Search Result for HOWARD COUNTY

SEWAGE DISPOSAL TESTING

F 90-177

Rebecca's Delight
F-90-177 (FORMER MILLER
PROP.)

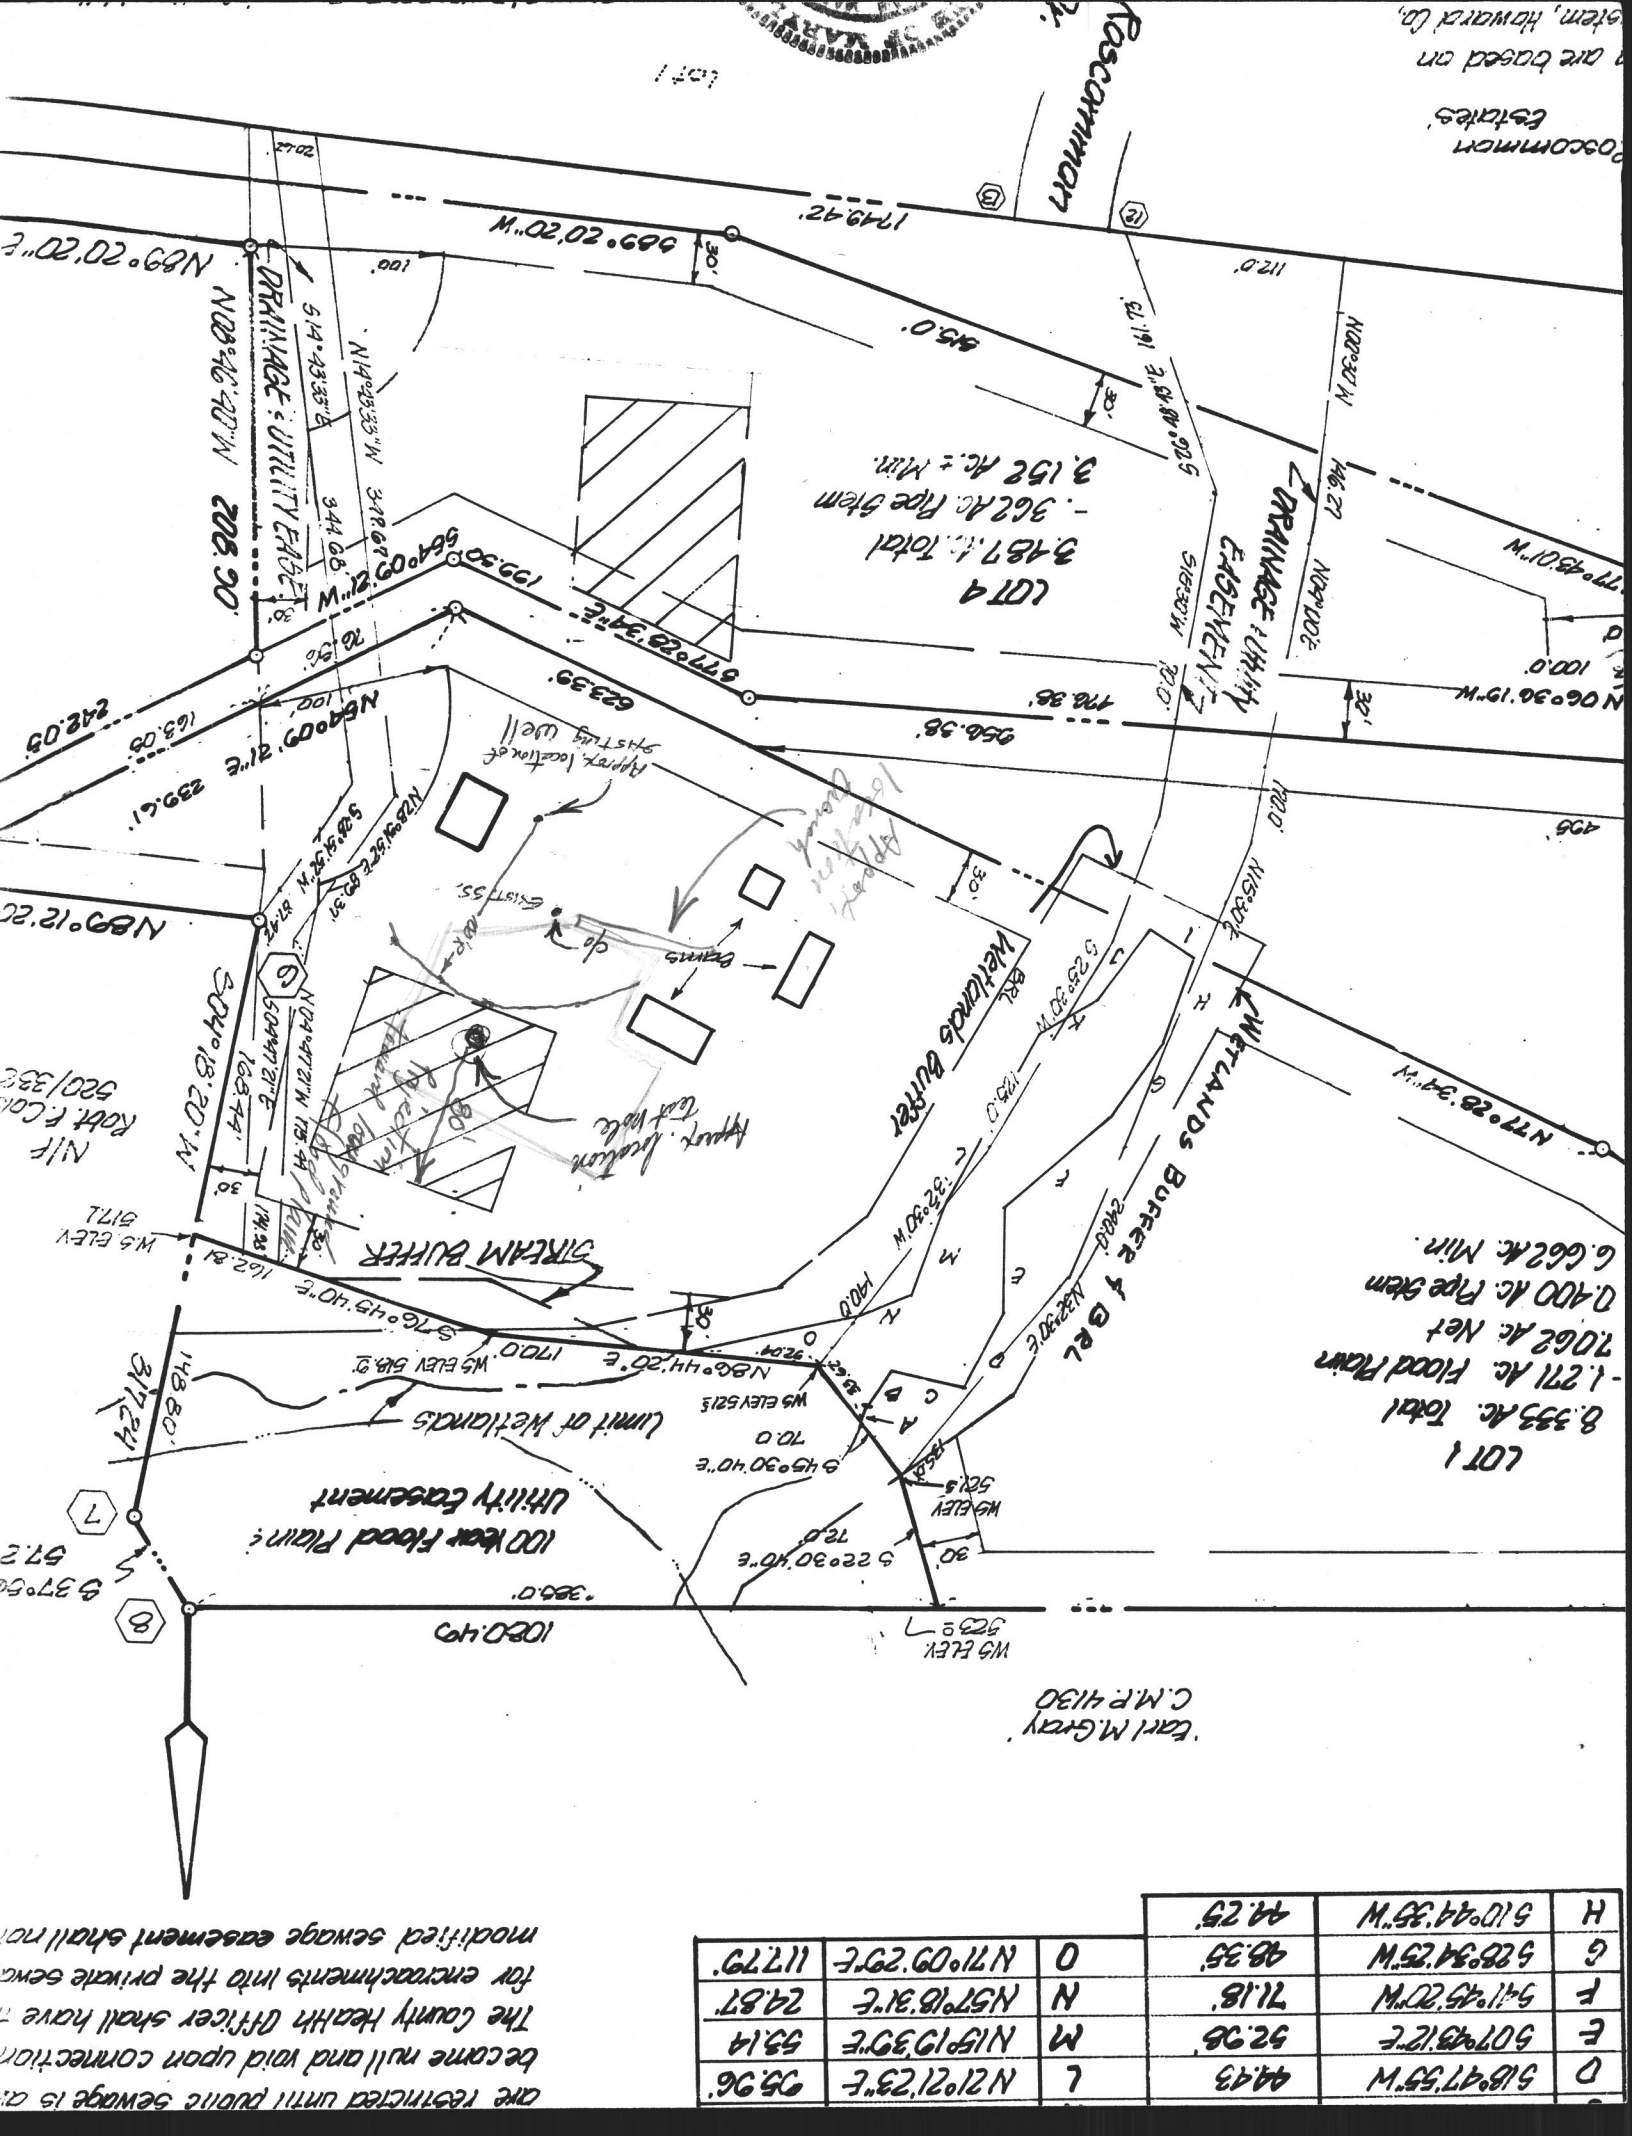
LOT 1 SEPTIC EASEMENT NOT ACCEPTABLE.

NO PERCS PERFORMED IN LOWER PART OF
PROPOSED SEPTIC AREA.
- TEST ON REUSE

POTENTIAL REVISIONS ARE IN CONFLICT
WITH EXISTING WELL LOCATION.
SEPTIC AREA ON LOT 4 PROHIBITS RELOCATION
OF LOT 1 WELL.

IF THE ONLY RESOLUTION TO LOT 1
IS A CHANGE IN WELL SITE,
THEN THERE MUST BE A COMPATIBLE
ADJUSTMENT TO LOT 4 SEPTIC AREA.

★ SIGNABLE PERC PLAT REQUIRED

PRIOR TO, OR SIMULTANEOUS WITH
FINAL PLAT.
